REMARKS

Reconsideration and withdrawal of the rejections to the claims set forth in the Office Action of June 10, 2005 are respectfully requested in view of the following remarks.

AMENDMENTS TO THE DRAWINGS

Annotated Sheet Showing Changes

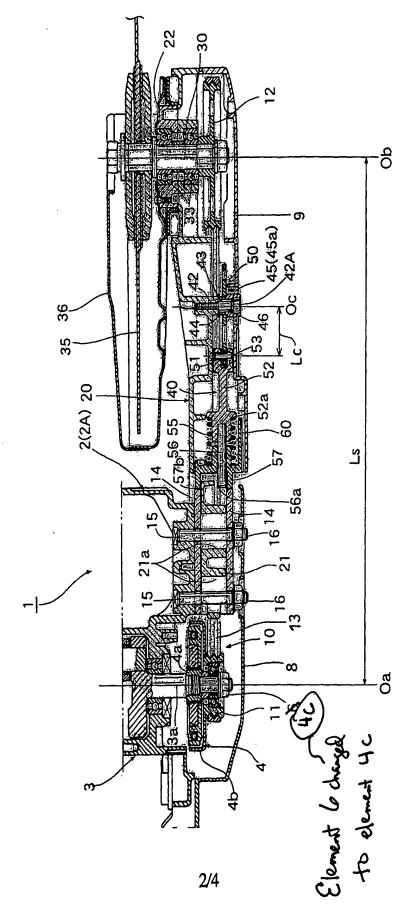
The Examiner has objected to Fig. 2 as failing to comply with 37 C.F.R. § 1.84(p)(4). Applicant has provided a replacement sheet for Fig. 2, showing element 6 being corrected to element 4c. Reconsideration and withdrawal of this objection are respectfully requested.

The attached sheet of drawings includes changes to Fig. 2. This sheet, which includes Fig. 2, replaces the original sheet including Fig. 2. In Figure 2, element 6 has been corrected to element 4c.
